**Economic Commission for Europe****Administrative Committee for the TIR Convention, 1975****Technical Implementation Body****Seventh session**

**eTIR conceptual, functional and technical specifications:****Version 4.4****Concrete amendment proposals****Note by the secretariat****I. Background and mandate**

Figure I  
**Current customs management of guarantees class diagram**

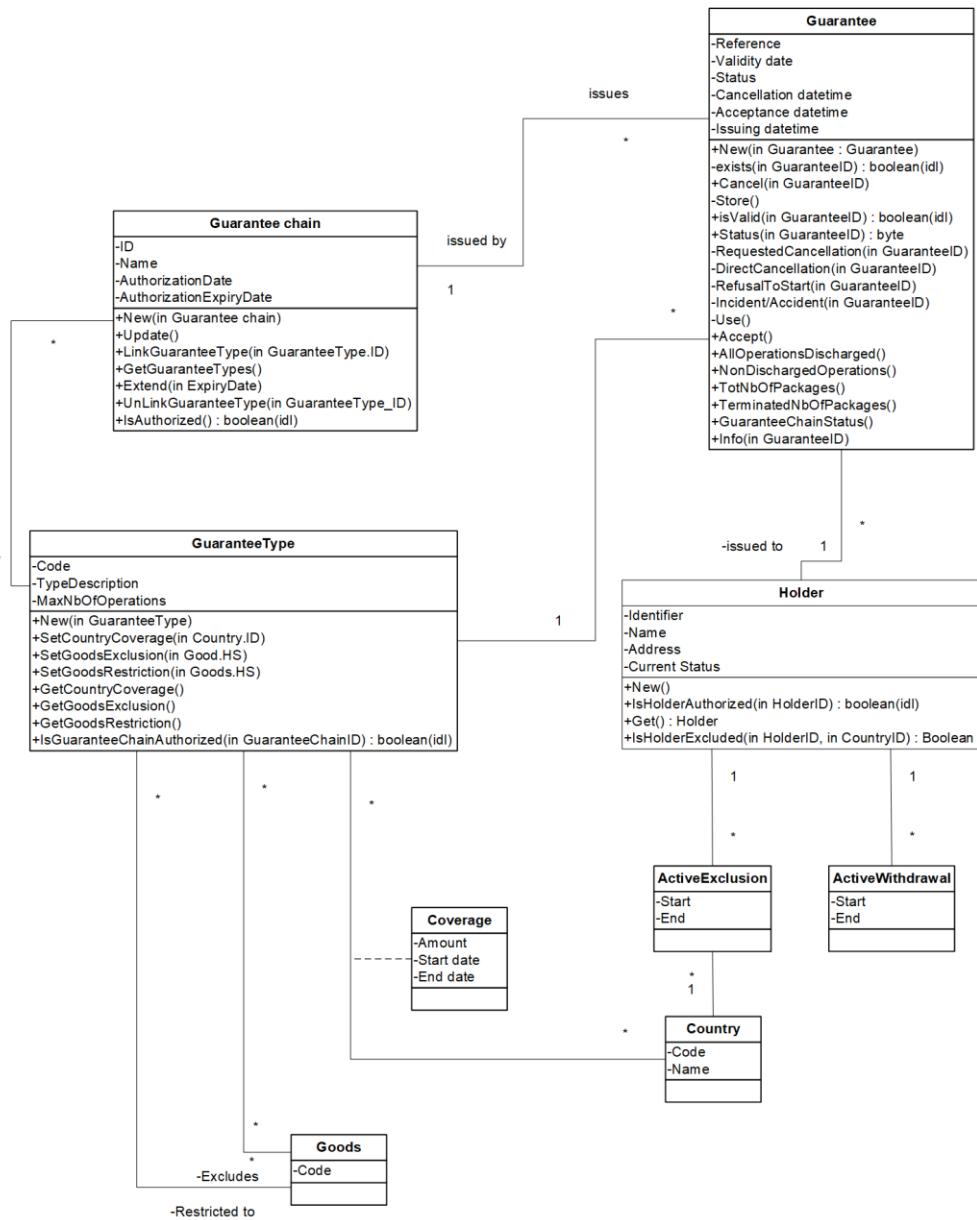
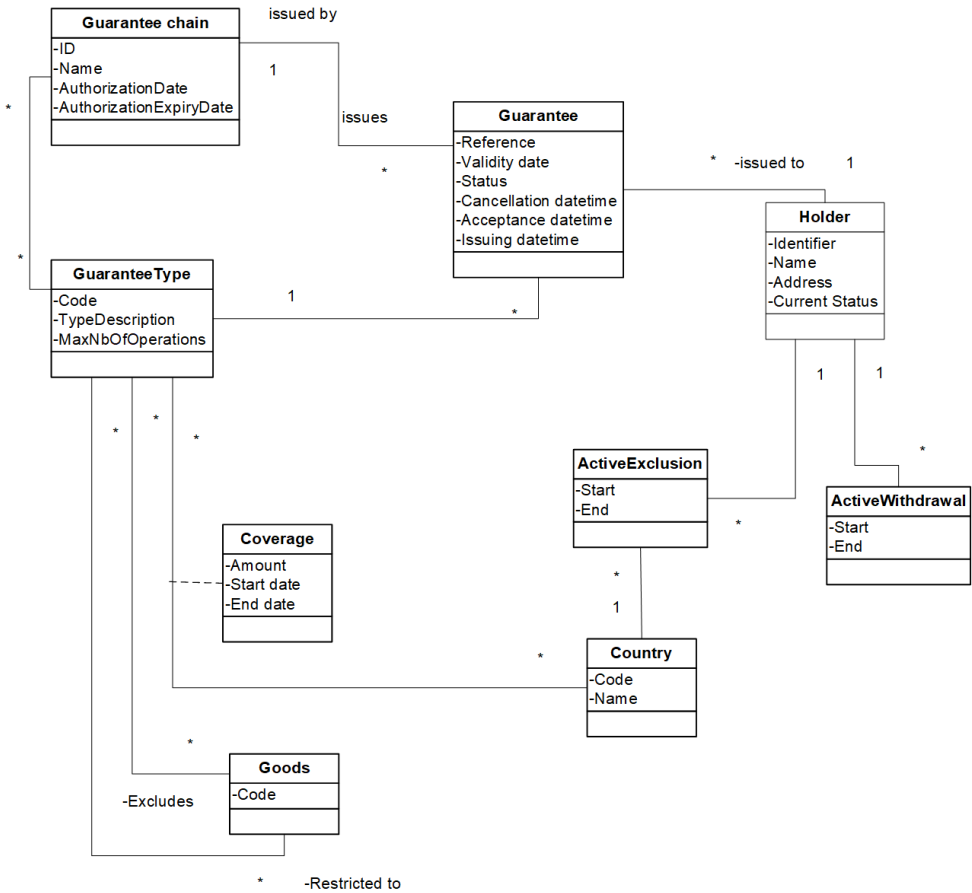
23. UML Class diagrams used in version 4.3 of the eTIR functional specifications contain not only classes, their relationships and their attributes, but also a set of methods that were aimed at facilitating the development of the eTIR international system. As such, these methods have little to no use for the countries that wish to amend their customs system to implement the eTIR procedure. Figures I and II below show the difference between the current and the simplified version of the customs management of guarantees class diagram (Figure 1.19 of the eTIR functional specifications).

24. At its third session, TIB agreed to simplify the class diagrams.

Figure V  
**Business Process Diagram for the Start TIR operation process**

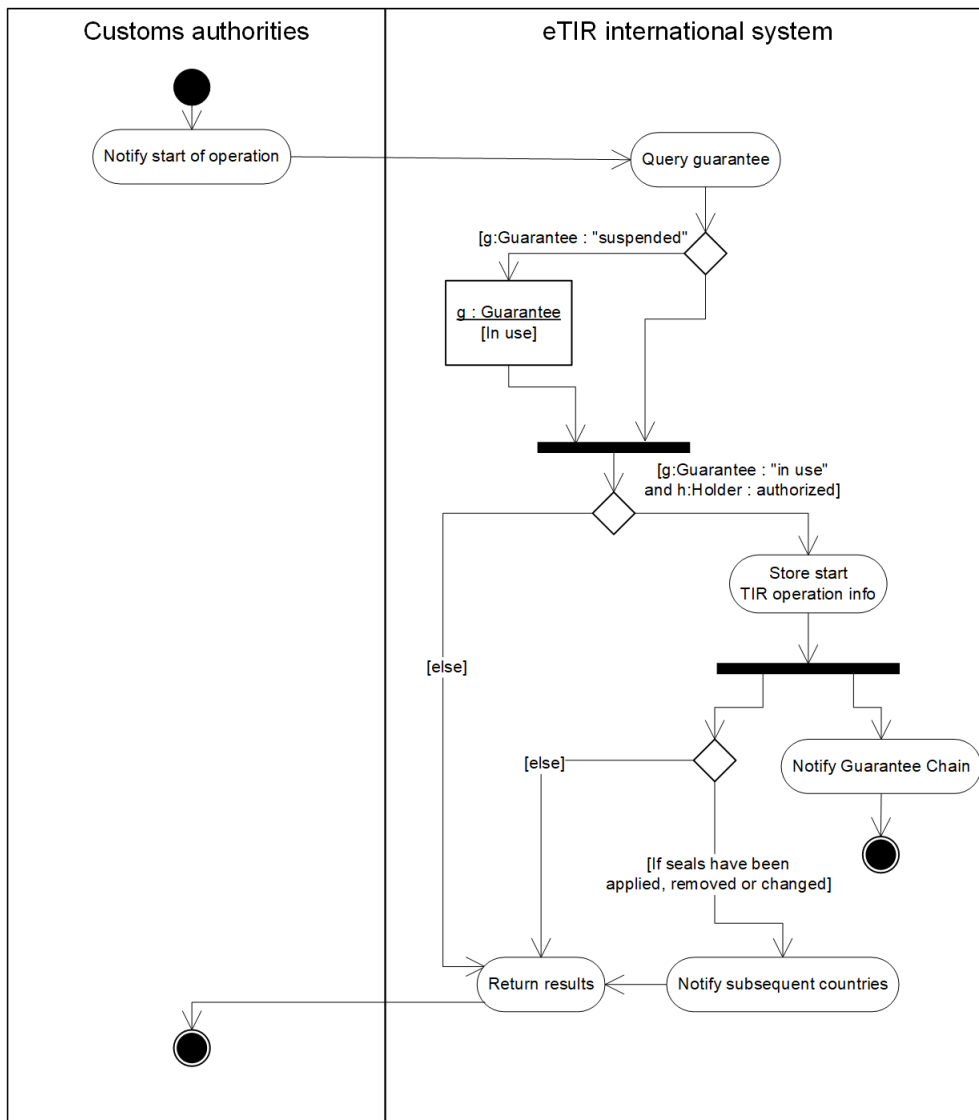
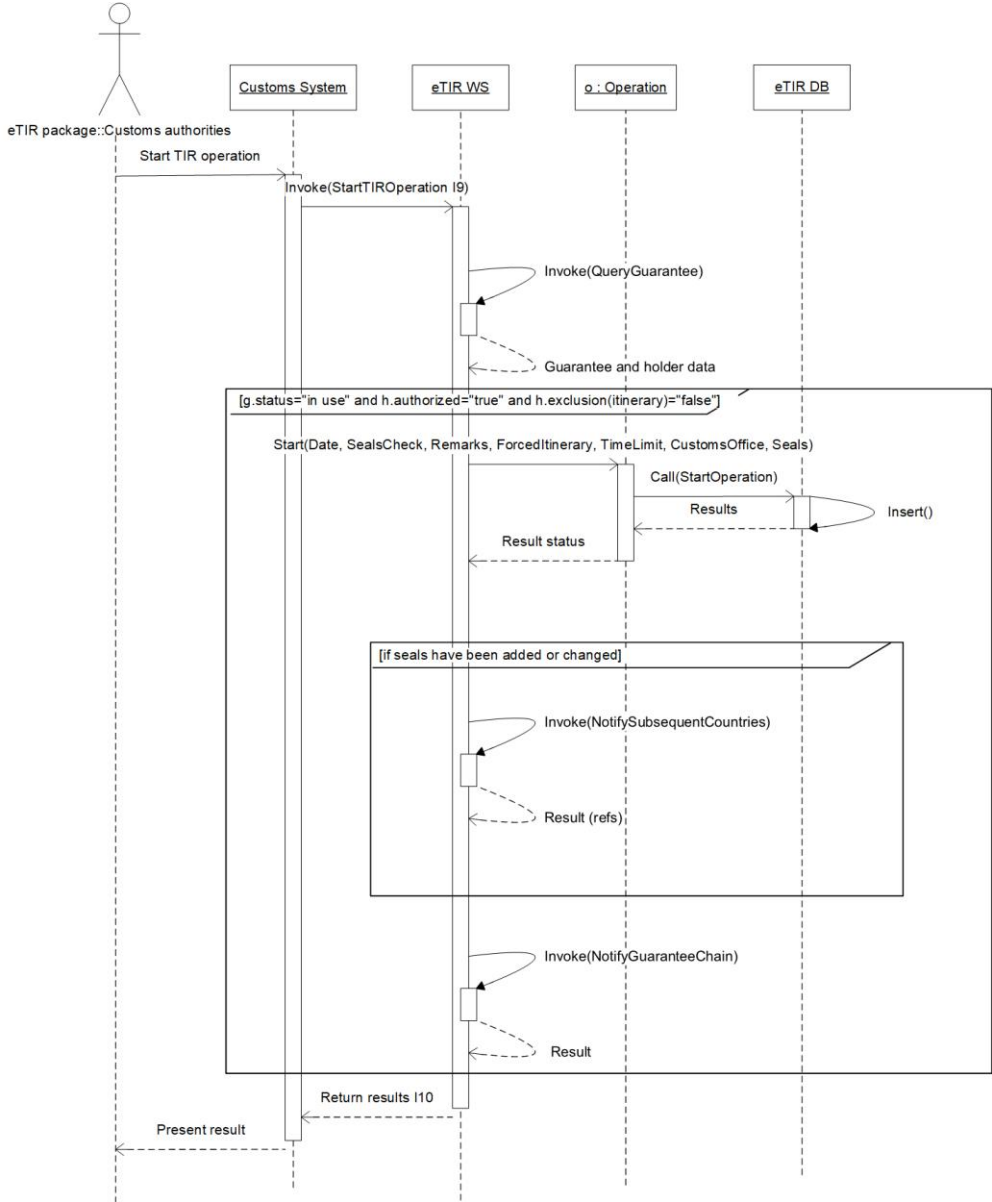
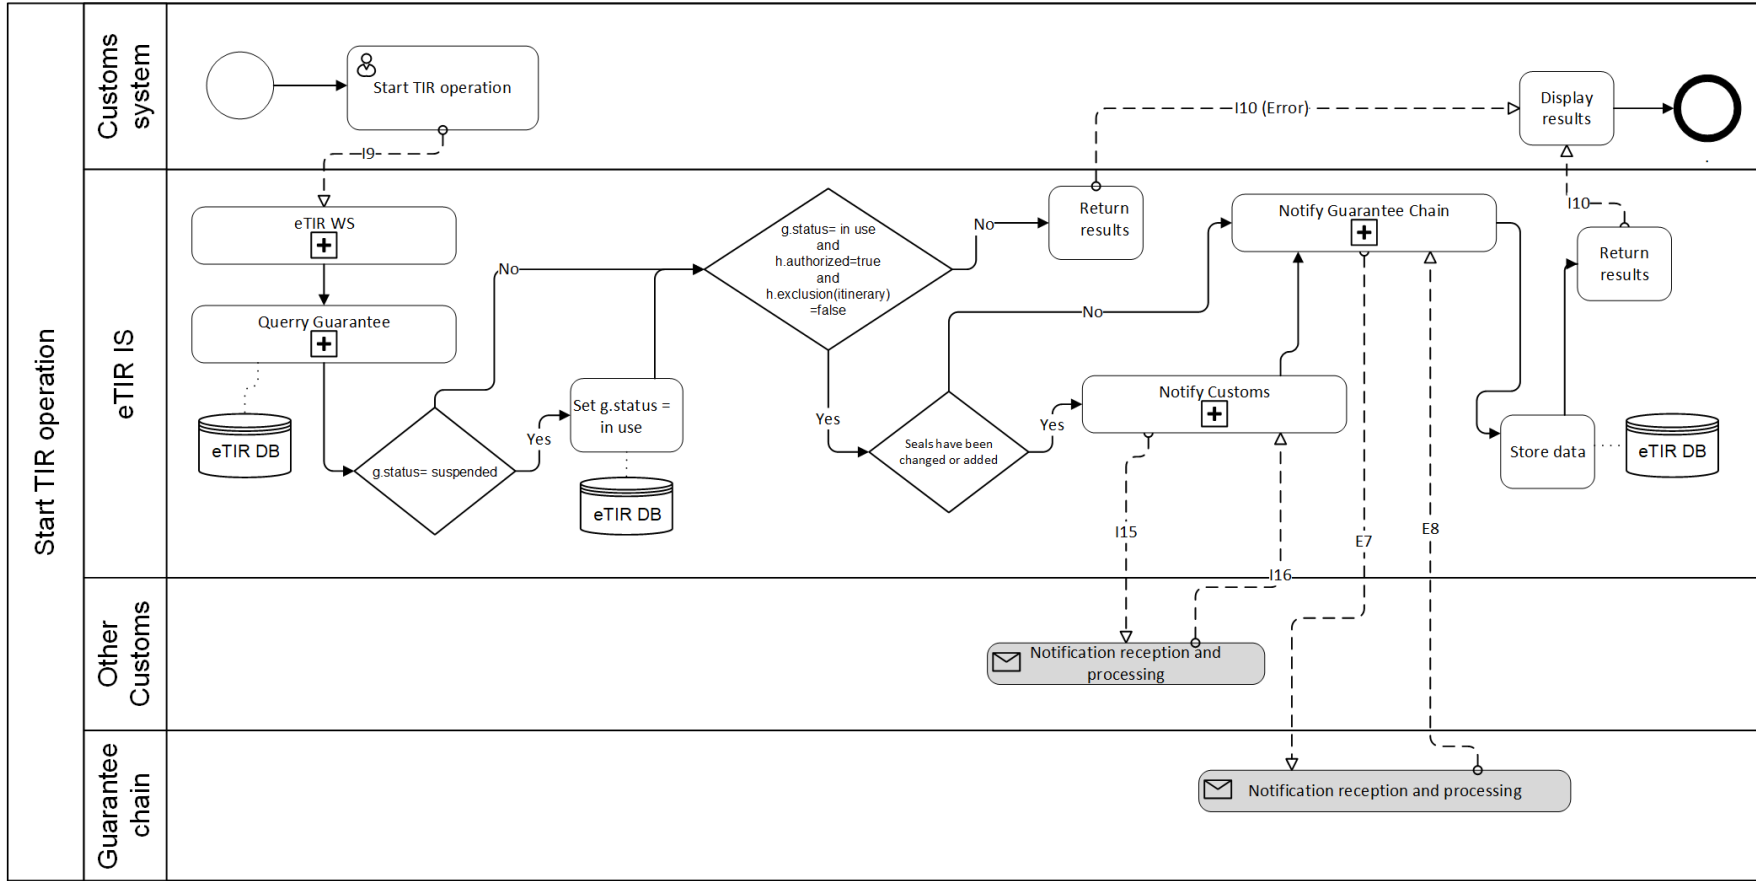
25. In version 4.3 of the eTIR specifications, in line with the Unified Modelling Methodology (UML) chosen originally for the eTIR project, the modelling of processes is done using UML activity and sequence diagrams. In recent years, the business process model and notation (BPMN) has gained in popularity in both the business and Information and Communication Technologies (ICT) communities and is, therefore, better understood by laymen and experts alike. With that in mind, TIB might wish to consider if, in version 4.4 of the eTIR specifications, BPMN should replace the activity and sequence diagrams used in version 4.3. Figures III, IV and V below show the UML activity diagram (Figure 12 of the eTIR concepts), UML sequence diagram (Figure 1.9 of the eTIR functional specifications) and the Business Process Diagram for the Start TIR operation process.

26. At its third session, TIB agreed to replace the existing diagrams (in Unified Modelling Methodology – UML) in the conceptual and functional specifications with the newly proposed diagrams (in Business Process Model and Notation – BPMN), in line with the examples above.
